Audrey Douinot et al. (2022) Flood patterns in a catchment with mixed bedrock geology: causes for flashy runoff contributions during storm events

Left: raw soil water content measurements at the four raingauge stations (from north to south); Right: standardized soil moisture preserving the temporal variation and fixing the maximum value to 100 %.

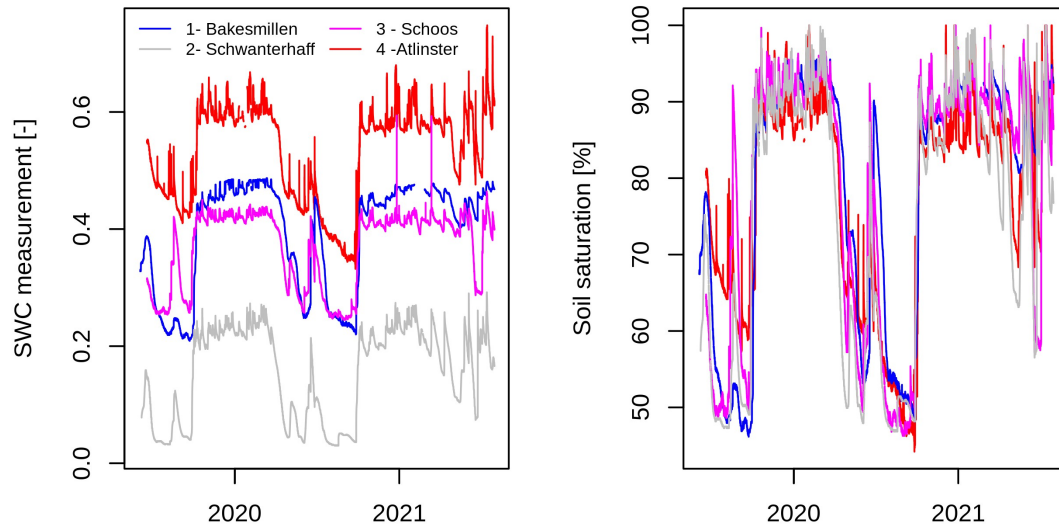
Figure 10: Does soil moisture mean volumetric soil water content? If so, 90% seems too high. Did you conduct calibration of Campbell CS650 using soil in the study site?

Having four soil water time series with different saturation levels in winter (Figure below, left), we indeed calibrated the time series, according to the porosity and the field capacity of each soil, to get the soil saturation level [%] (Figure below, right). Figure 10 indeed shows the soil saturation level and not the soil moisture content. This has been reworded in the legend:

*„Figure 10. Left: The catchment state at the start of each event (points): The minimum discharge during the 7 days before the event ( $Q_{base}$ , [ $m^3 \cdot km^{-2} \cdot s^{-1}$ ]), and the soil saturation at 20cm in depth (SWC20 [%]). The light blue colour corresponds to the weekly average discharge minimum at Koedange (solid line) and Medernach (dashed line) over the studied period. The red line corresponds to the soil saturation calendar day average at 20 cm depth in the Medernach catchment over the same period.“*
